VIRGINIA ELECTRIC AND POWER COMPANY (DOMINION)
NORTH ANNA POWER STATION UNITS 1 AND 2
NORTH ANNA INDEPENDENT SPENT FUEL STORAGE INSTALLATION
RESPONSE TO REQUEST FOR ADDITIONAL INFORMATION (RAI)
RESTART READINESS DETERMINATION PLAN

Response to Request for Additional Information
North Anna Restart Readiness Determination Plan

Response to NRC Request for Additional Information
Restart Readiness Determination Plan
North Anna Power Station Units 1 and 2

Figure 1 – Main Station Batteries

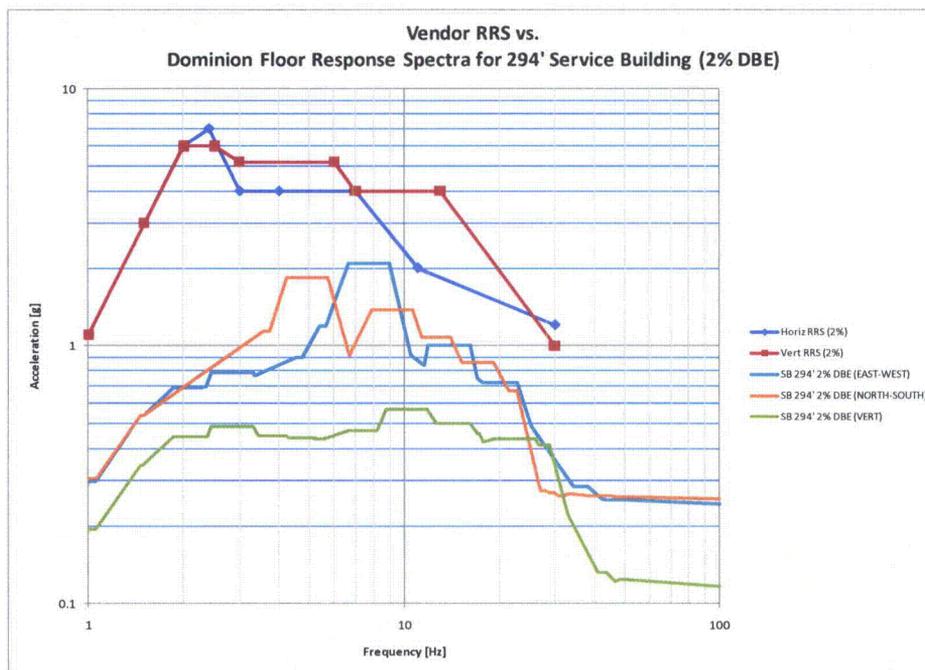
22. For a representative sample of safety related components, please confirm, prior to restart, that the test response spectrum (TRS), or the seismic input motion used in the original seismic qualification of the component, envelop the instructure response spectra (required response spectrum (RRS)) developed using the recent earthquake input motion data. As a minimum, the sample for this evaluation should include the following:

As shown in the test report, the Test Response Spectra in 2GN-23 battery qualification report envelops the vendor's Required Response Spectra with margin for the OBE and SSE tests conducted. The vendor's RRS also envelop the North Anna Floor Response Spectra (FRS) for the 294 feet elevation of the Service Building with substantial margin (as shown in Figure 1).
